Subject: Request for Elimination of Soil Vapor Sampling Locations from Montgomery Downtown Environmental Assessment Project's Technical Work Plan

FIGURE 1
 County Annex III and Alabama AG's Buildings
 Proposed Soil Vapor Sampling Locations
 Downtown Environmental Assessment Project
 Montgomery, AL

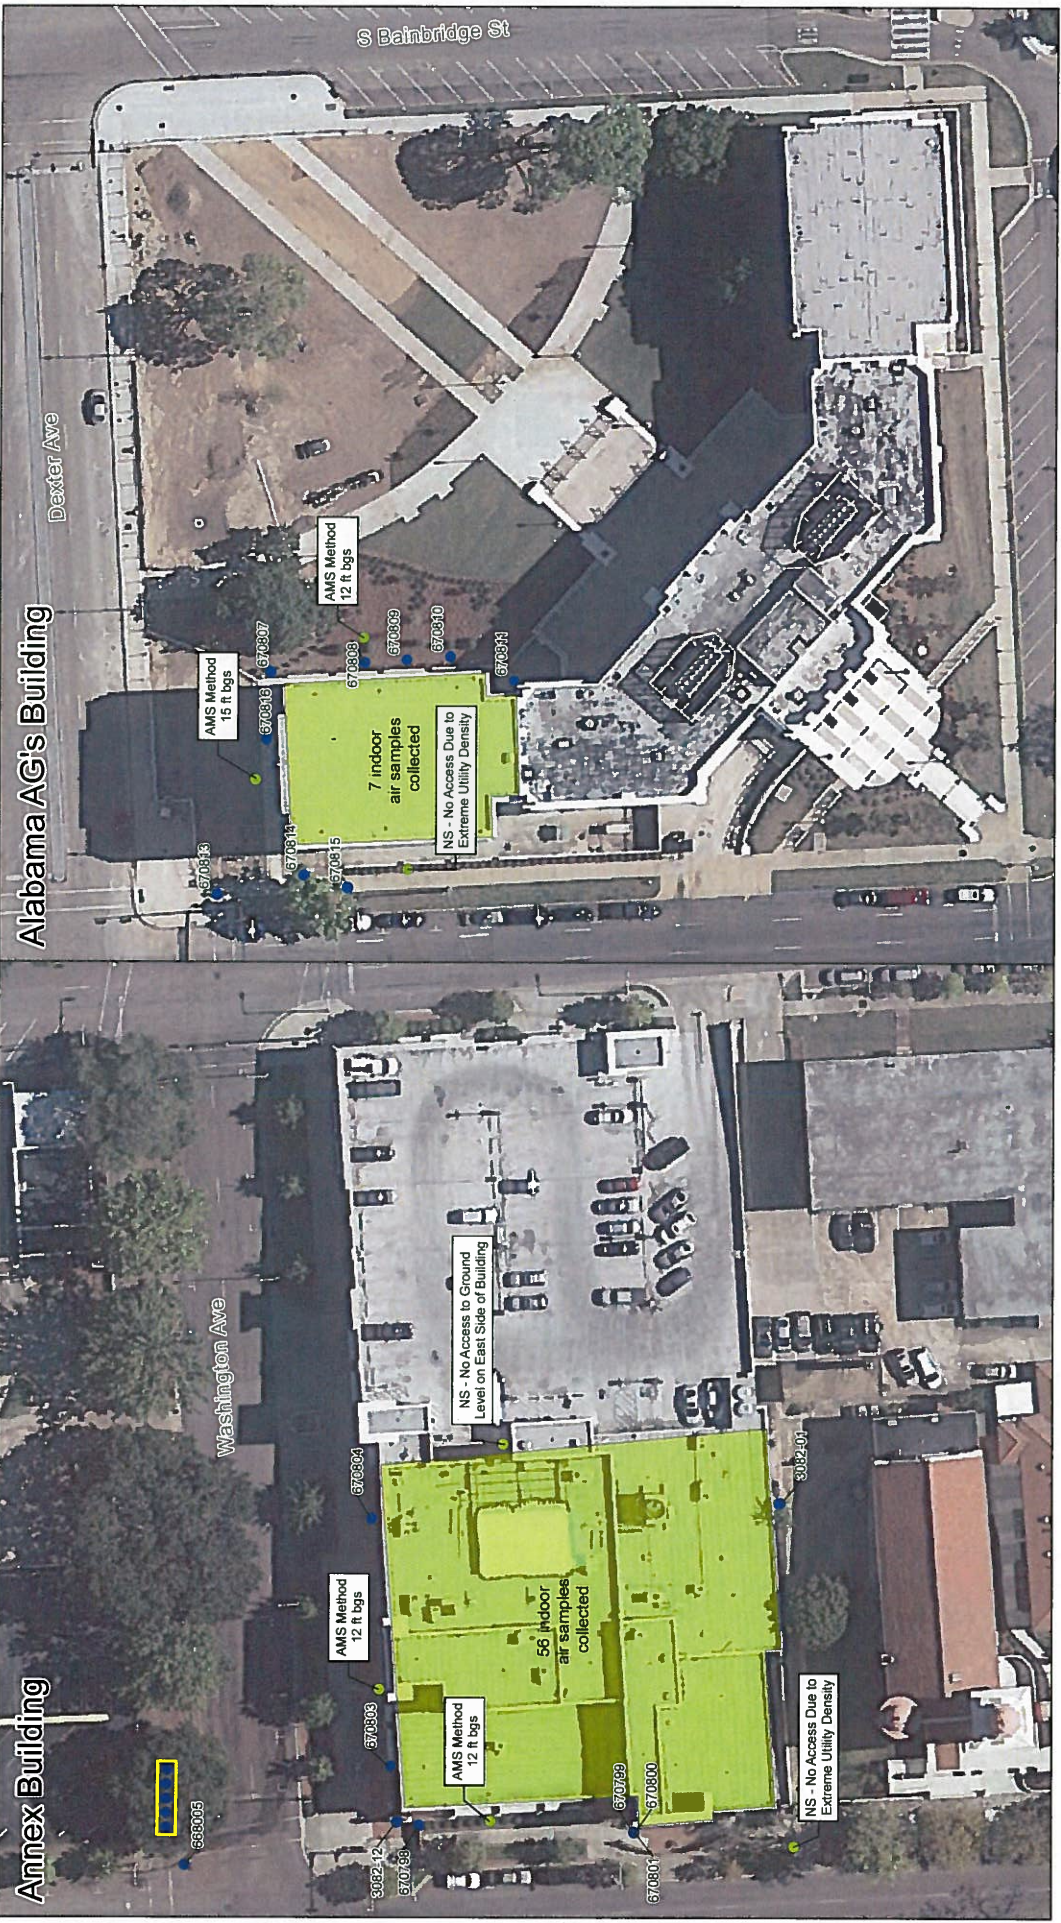
- **County Annex III Building South Sample Location** – Review of this location revealed that there are multiple underground utilities (including water, electrical, natural gas, and an unmarked storm sewer) that prevent this location from being sampled. The DEA attempted to identify a sampling location between the south wall of the building and the concrete retaining wall on the southern property line, but there is insufficient space for the direct-push rig to access an alternative location. Therefore, it was mutually agreed by the DEA and ADEM that this sampling location would be eliminated, as there is no reasonable alternative sampling location for the south side of the County Annex III Building.

- **County Annex III Building East Sample Location** – Review of this location revealed that there is no access to an external, ground-level location on the east side of the building because it is directly above a basement lobby. Further reconnaissance of the building revealed that there is no other location on the east side of the building where sampling could be safely performed. The only location that might have provided a ground-level access point is adjacent to a room marked with a high-voltage electrical sign. Therefore, it was mutually agreed upon by the DEA and ADEM that this sampling location would be eliminated, as there is no reasonable alternative sampling location for the east side of the County Annex III Building.

- **Attorney General's Building West Sample Location** – Initially, two attempts to take samples on the west side of the Attorney General's Building failed because of a concrete obstruction that was not initially marked by GPRS, the private utility locating company retained for the sampling event. On September 21, 2016, GPRS returned to the site and surveyed the area west of the building. This survey revealed that multiple underground utilities (including multiple electrical lines, a telecommunications line, and storm sewers) prevented this location from being sampled. GPRS

indicated that attempting to sample in this area was dangerous because of the presence of underground power lines. Therefore, it was mutually agreed upon by the DEA and ADEM that this location would be eliminated, as there is no reasonable alternative sampling location for the west side of the Attorney General's Building.
